WOODBERRY FOREST SUBDIVISION ADDITIONS

APPLICATION NUMBER 23 DATE February 7, 2008

DETAIL SITE PLAN

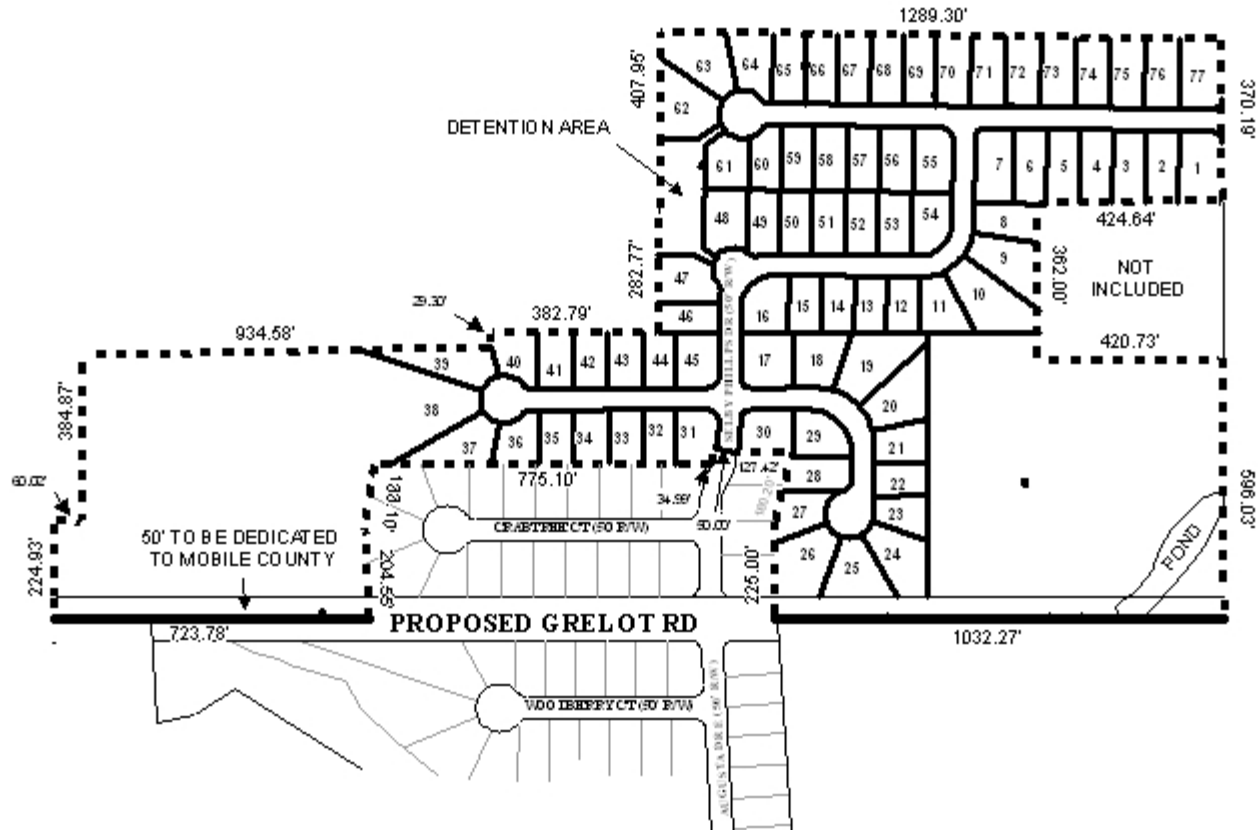
The 25-foot minimum building setback is not shown on the plat, but is required. The setback line should be depicted from all existing and proposed street frontages and labeled.

Detention common areas proposed for the subdivision. All common areas should be labeled, and a note should be placed on the Final Plat, if approved, stating that maintenance of the common areas, including detention areas and any other common areas, are the responsibility of the subdivision's property owners

The plat should be revised to show lot size in square feet, or a table provided on the plat with the same information.
